SUBJECT:- FRONT SUSPENSION ADJUSTER CAM.

MODELS AFFECTED.	INTRODUCED AT CHASSIS NUMBERS.	
	RHD	LHD
SERIES 3 'E' TYPE OPEN	1S.1348	1S.20569
SERIES 3 'E' TYPE 2+2	1S.51263	1S.73372

SUBJECT: CAM FOR ADJUSTING RIDE HEIGHT ON FRONT LOWER WISHBONE

SUBJECT: **UPPER BALL PIN KIT**

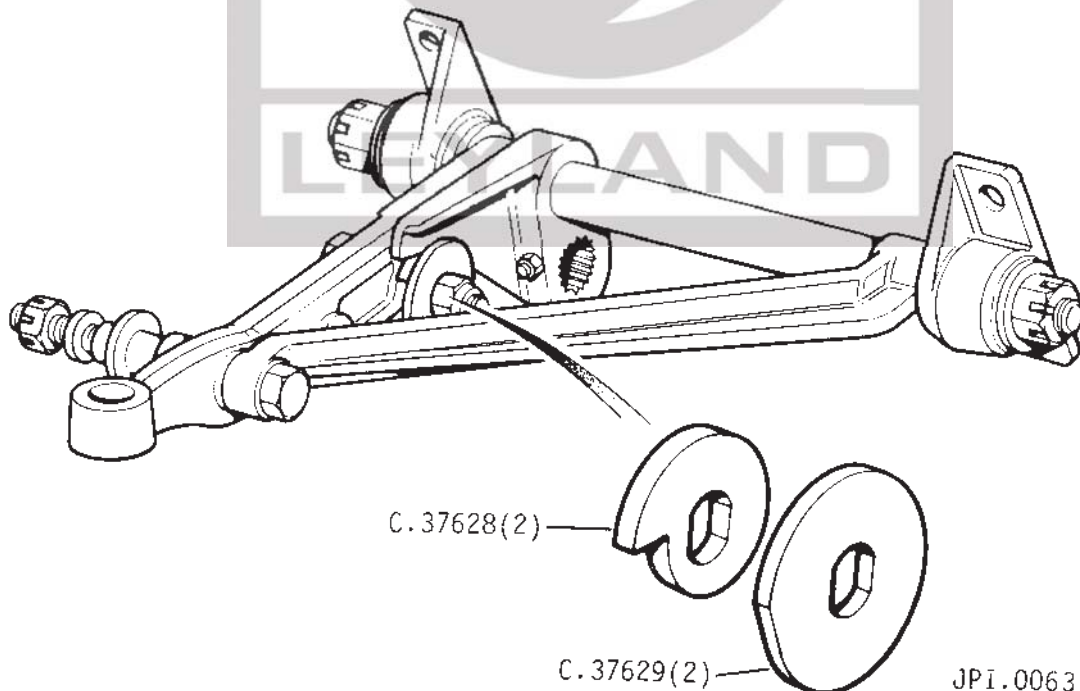
MODIFICATION: Supplies of the first type cam for adjusting the front suspension ride height C.33096 can no longer be obtained. Should this part require replacing it will be necessary to fit the later cam C.37628 together with the later retaining washer C.37629.

C.37628	2	Cam, on front suspension lower wishbone, for adjusting ride height	C.33096	
C.37629	2	Retaining washer for cam	C.33102

Fig. 2   Upper ball pin kit

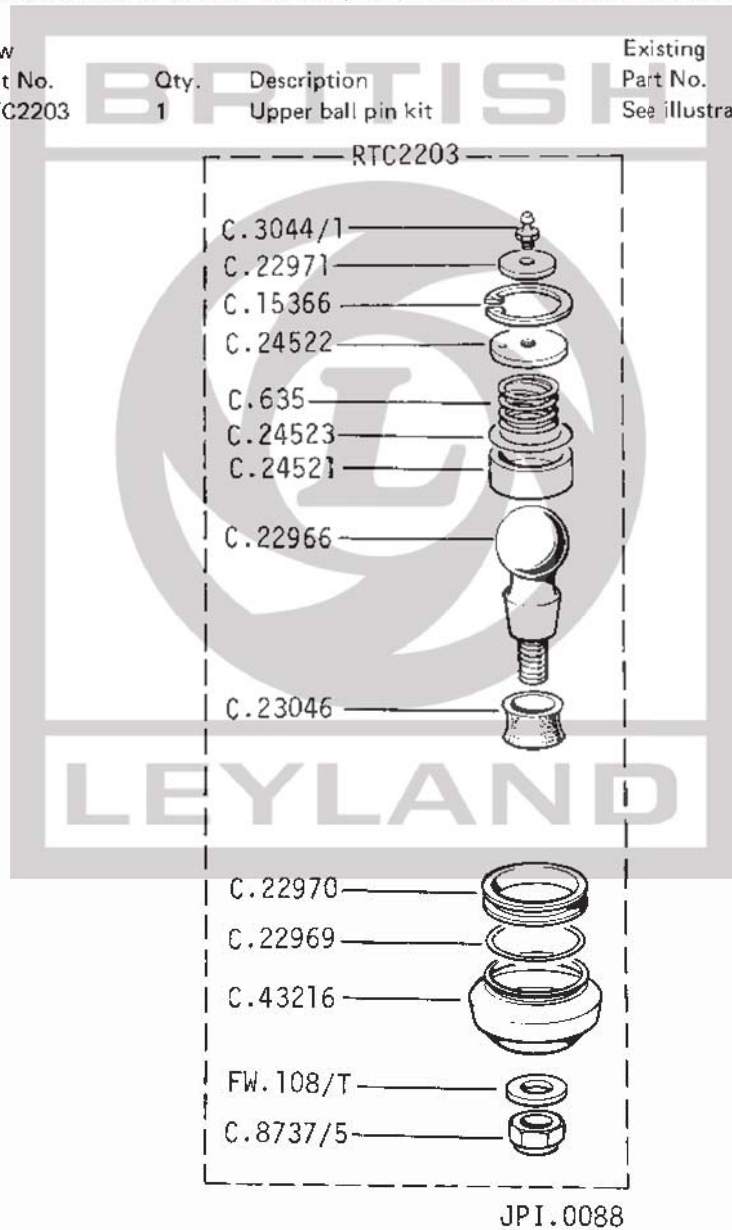
MODIFICATION: Introduction of a kit for the complete overhaul of the Upper Ball Pin on the Front Suspension.

PART NUMBERS:	New Part No.	Qty.	Description	Existing Part No.	Remarks
	RTC2203	1	Upper ball pin kit	See illustration
